RE: **Fort Hills Oil Sands Project – McClelland Lake Wetland Complex Operational Plan  
Water Act Approval No. 151636 (as amended), Conditions 3.11, 3.12, 3.13 and 3.14  
Oil Sands Conservation Act Approval 92411 (as amended), Condition 8**

**McCLELLAND LAKE WETLAND COMPLEX  
OPERATIONAL PLAN**

Table1: SC and TAG Comments on the Revised MLWC Operational Plan (OP)				
#	Page #	Recommendation/Request	SC or TAG Member	Fort Hills' Response
		<p>Conditions set in the Water Act clearly note that both ecosystem diversity as well as function need to be maintained in the non-mined portions of the MLWC.</p> <p>Suncor definition of the Non-mined Portion of the McClelland Lake Wetland Complex (shown in Figure 1.1-1) clearly includes the portions of the MLWC within and outside of the Fort Hills Lease, and McClelland Lake.</p> <p>Note from Co-chairs: A lake needs to include the littoral and riparian zones, to be functional.</p>		
6	Introduction General Comments - i	Within each group that is acknowledged, I would list the person in alphabetical order.	TAG - VEGETATION	Thank you for this suggestion. We have arranged the TAG group in alphabetical order.

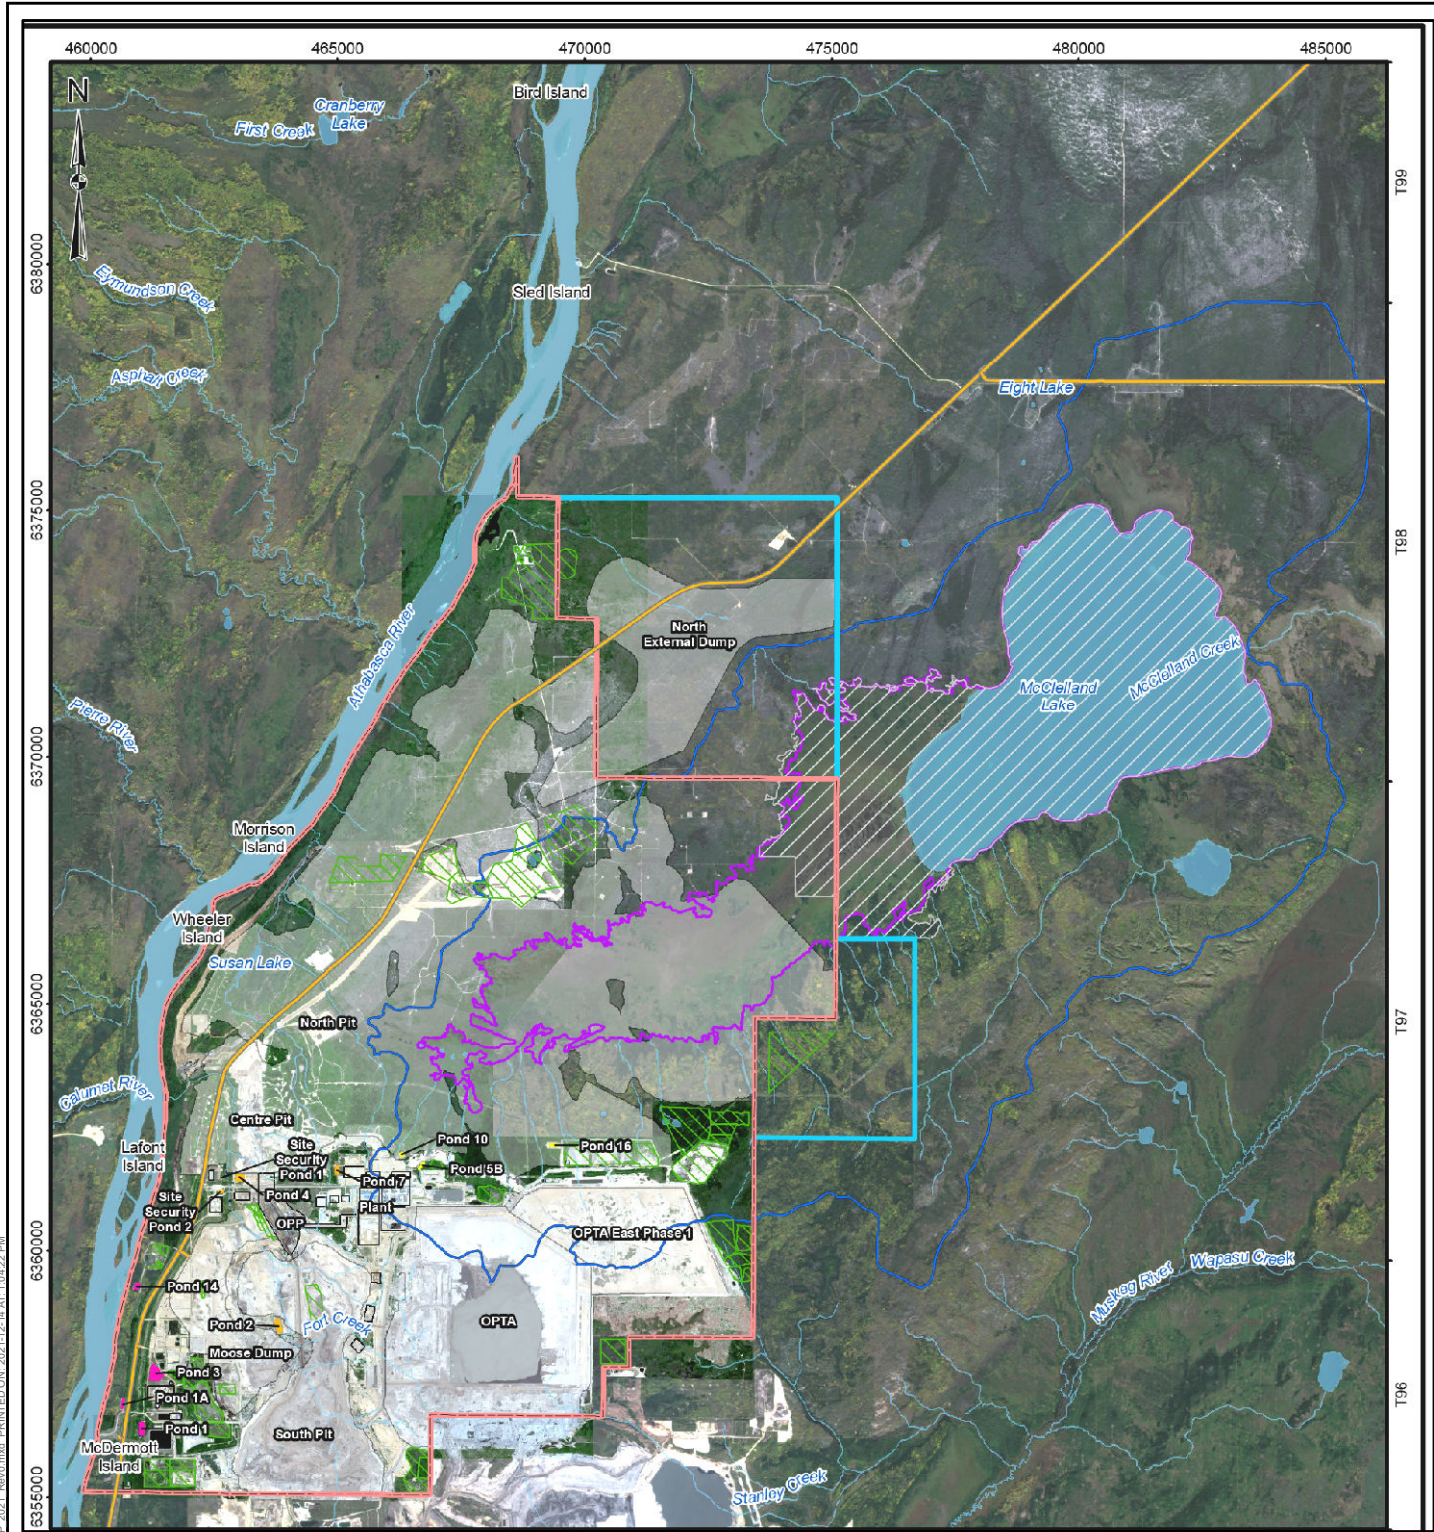
30	Introduction – Specific Comments - 1-1 to 1-6	<p>Figure 1.1-1 is very small and very difficult to read yet it provides very important information. Please put this document in as a 11 x 17 figure.</p>	<b>CO-CHAIRS</b>	Apologies but the shape of this map isn’t conducive to providing in 11x17. That said, the zoom feature in the digital version is enabled so the reader can zoom in on any detail necessary.

**Figure 1.3-1: Illustration of the Sustainability Committee and Advisory Group Lines of Communication**

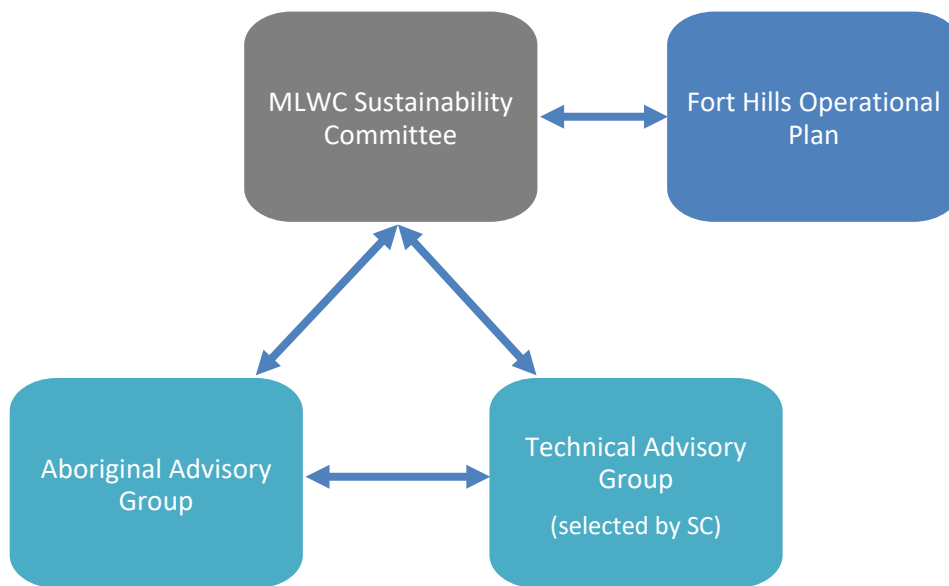
11	Introduction – Specific Comments - 1-7 Figure 1.3-1	Figure 1.3-1 is adapted from the AAG ToR and includes the lines of communication from that original figure. Please correct the Figure title to “Lines of Communication of the MLWC Sustainability Committee”. If the intent is to have an organizational structure then it would be Fort Hills Energy Corporation not Fort Hills Operational Plan and the two headed arrow between the SC and FHEC should be two arrows to denote that FHEC is making the final decisions with respect to the Plan’s contents and SC is providing recommendations on what the contents should be.	FMCA/FMMN	Accepted and revised.
12	Introduction – Specific Comments - 1-8 to 1-9	<p>The Last full sentence bottom of page 1-8 and first sentence top of 1-9 are stated poorly. A revision is required for clarity and accuracy. We recommend deleting: <i>People’s body of knowledge to shape and manage the land for sustainable use grew as they moved on the land.</i> This statement confuses concepts and the entire paragraph has better clarity without it.</p> <p>We recommend revision to the following sentence to read instead: <i>The nature of peoples' relationship with the land and the intrinsic obligation that comes with that, to steward the health and respectful use of the land for cultural continuance, is a core philosophy value and belief in the worldviews of...</i></p>	FMCA/FMMN	Accepted and revised. Thank you for providing specific wording!

**Figure 1.4-1: Operational Plan Objectives**

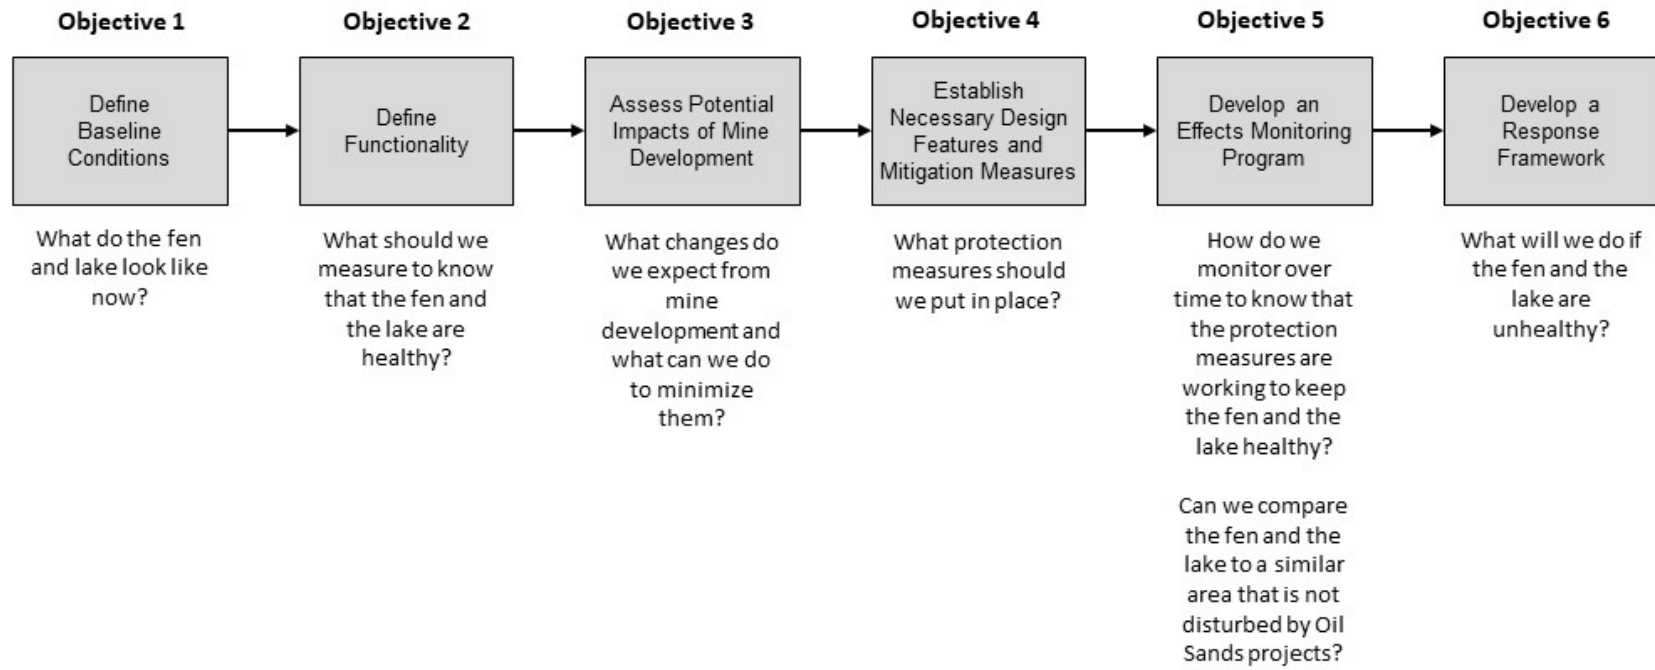
24B	Page 1-15	The OP will be a "living document". When and how will it be updated? Perhaps the incorporation of iterative "loops" in Figure 1.4-1 would better indicate that most sections (objectives) will be revisited, and modified accordingly, with future data and understanding throughout the operations	TAG-Hydrology	See response to item #1B
<b>2.0 Objective 1: Baseline Conditions – 2.1 General Comments</b>				
		NO NEW COMMENTS		
<b>2.0 Objective 1: Baseline Conditions – 2.2 Adequacy of Response to Initial Recommendations</b>				
25B	Objective 1 - SC Recommendation [1]	<b>PARTIALLY ADDRESSED:</b> If the commitments for further work can be considered sufficient and appropriate to call the OP complete, then this item is addressed; however, there are a number of outstanding issues to be addressed by the future commitments. TAG still suggests that it may take a year or two to complete work on reference ecosystems, collect more baseline data, update modelling, and evaluate monitoring/trigger requirements. The amount of water quality work required is unknown. Ultimately it is up to the regulator to accept the OP. Perhaps the regulator will accept that these deficiencies can be rectified in the near future.	TAG-Hydrology	See response to item #1B
